UNITED STATES PATENT AND TRADEMARK OFFICE

APPLICATION NO.	FILING DATE	FIRST NAMED INVENTOR	ATTORNEY DOCKET NO.	CONFIRMATION NO.
10/681,983	10/09/2003	Chun Ho Fan	618902001410	8846
25227	7590	01/28/2008	EXAMINER	
MORRISON & FOERSTER LLP			ANDUJAR, LEONARDO	
1650 TYSONS BOULEVARD				
SUITE 400			ART UNIT	PAPER NUMBER
MCLEAN, VA 22102			2826	
			MAIL DATE	DELIVERY MODE
			01/28/2008	PAPER

Office Action Summary	Application No.	Applicant(s)
	10/681,983	FAN ET AL.
	Examiner	Art Unit
	Leonardo Andújar	2826

DETAILED ACTION

FIG. 11B

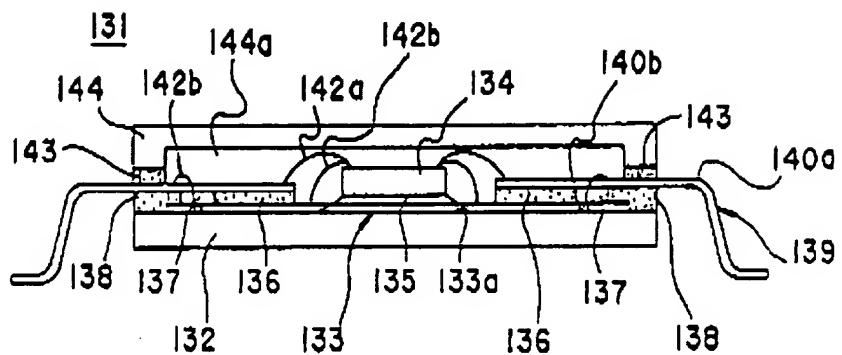
4. Regarding claim 11, Tesjui (e.g. fig. 11b) shows a integrated circuit package comprising: a first lead frame 133 having a first side and a second side, opposite the first side; a second lead frame 139 laminated to the first side of the first lead frame (e.g. top side) in order to create a multi layer lead frame; and a semiconductor die 134 mounted to another portion of the first side of the first leadframe

FIG. 7

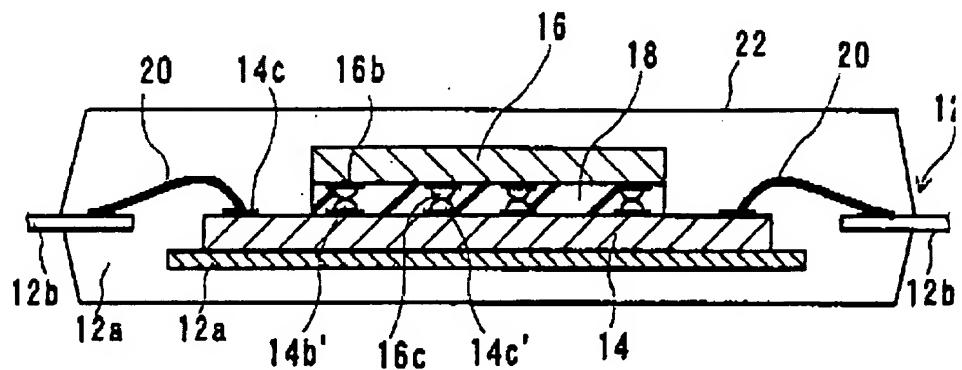
Tsuji does not show a plurality of contacts balls mounted on the semiconductor die. However, Morifuji (e.g. 7) shows a semiconductor device 14 having a plurality of contact balls 14b' mounted on the semiconductor die. According to Morifuji, this type of embodiment increases the integration density while preventing the semiconductor chip from warping and from being damaged (col. 1/lls. 5-44).

It would have been obvious to one of ordinary skill in the art at the time the invention was made to include contact balls on the semiconductor die disclosed by Tsuji

in accordance with Morifudi's invention to increase the integration density while preventing the semiconductor chip from warping and from being damaged.
